# Historical Architectural Review Board COA Preliminary Review Sheet

**HDC-2026-00002**

**Address:** 943-951 W Chew Street

**Proposal:** Replace windows, modify door openings

## Proposed Chew St Elevation (Applicant)

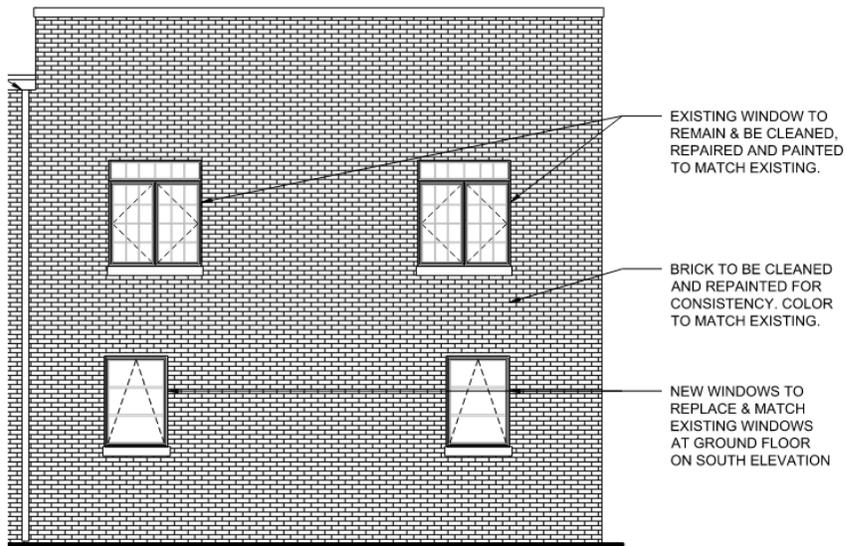
The proposed drawings indicate modifications to doorways along W. Chew Street. The single door at the west end is proposed to be removed and infilled with brick, and the front stoop removed. The single door appears to be an original opening with an original transom and replacement door. Given the unique configuration of the first floor openings, including an irregular array of window and door sizes, removal of this door would not create a negative impact on the façade. Since the doorway appears original, slightly recessing the brick infill of the doorway so that the original doorway size can still be perceived would be an appropriate treatment of the opening.

The loading dock door is proposed to be removed and replaced with brick and a pair of windows similar to adjacent pairs of windows. The door itself is concealed, and it is unknown if the original door exists. The dock bumper does not appear on the proposed drawings. The loading dock is a unique feature on the façade that was directly related to the former commercial use. A more appropriate treatment of this opening would be to retain the loading dock bumper and maintain the overall dimension of the door opening by replacing with fixed doors, or by utilizing a different infill material, such as a fiber cement.

- Replacement windows are metal windows with muntin configuration and operation as proposed
- Single door brick infill is recessed by ½” to 1” from the wall surface so that the original door opening size is preserved.
- The loading dock bumper and opening size is retained. If the opening is infilled, a differing material such as fiber cement is used.

- Replacement windows are metal windows with muntin configuration and operation as proposed
- Western single door brick infill is recessed by 1/2" to 1" from the wall surface so that the original door opening size is preserved and vertical elements continue to sidewalk.
- The loading dock bumper and opening size is retained. If the opening is infilled, a differing material and/or differing window material can be used, retain a 1/2" to 1" recession.
- Any painted masonry surfaces should utilize a breathable coating

Proposed Window Details (Applicant)

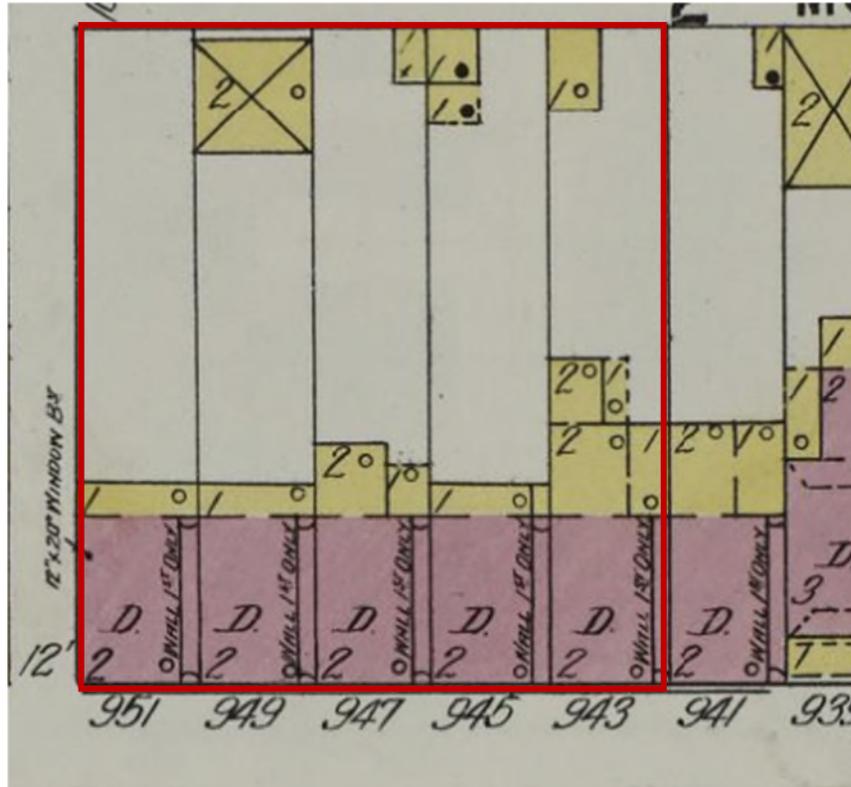
The proposed windows are aluminum-clad wood windows with muntin patterns that resemble the current configuration of the existing metal framed windows. Given the industrial style of the structure, metal framed windows would be more appropriate in materiality, frame dimension, and sightlines.

Mr. Knee asked the Board about the appropriateness of the window materiality. Mr. Encelewski, Mr. Hart, and Mr. Huber opined that metal framed windows would be more appropriate than aluminum-clad wood for the industrial building.
